STANDARD FIELD SERVICE BULLETIN

FSB Number	CHRAEFSB2014-116
Author	Rajesh Verma
Date	11/24/2014
Subject	Moto X (2nd Generation) - Camera Cannot Focus/Blurry Image
Model Affected	XT1092, XT1093, XT1094, XT1095, XT1096, XT1097
Level Of Repairs	Level 2

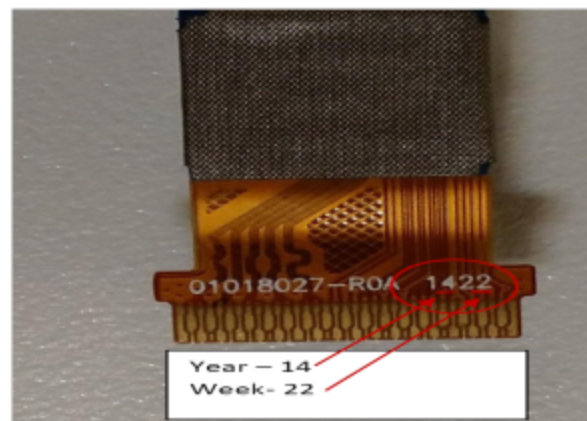
Engineering analysis root caused this issue to a supplier manufacturing process issue where Camera housing coil was shorted with camera shield case.

The camera supplier has implemented process improvements to resolve these issues as of August 27, 2014. Date Code 1435 and later.

- Cannot Focus
 - Blurry Image
 - Blurry Video
 - Picture Quality No Good
1. Following Service Manual, carefully disassemble the phone to gain access to the Rear Camera Module (Service P/N: 01018027001).
 2. Replace Rear Camera Module (Service P/N: 01018027001) with known good Date Code 1435 or later. See below image example to decode date code.
 3. Per Service Manual, reassemble the phone.
 4. Inspect Rear Camera operation for any focus, blurry images or picture quality issues.
 - a. If issue persist, then this bulletin does not apply. Follow normal troubleshooting to determine the problem.
 5. Following Service Manual, Completely reassemble and retest the device, per standard Service procedures, to ensure proper repair.

- Stock Rear Camera Module (Service P/N: 01018027001) Date Code 1435 and later. See below image example to decode date code.
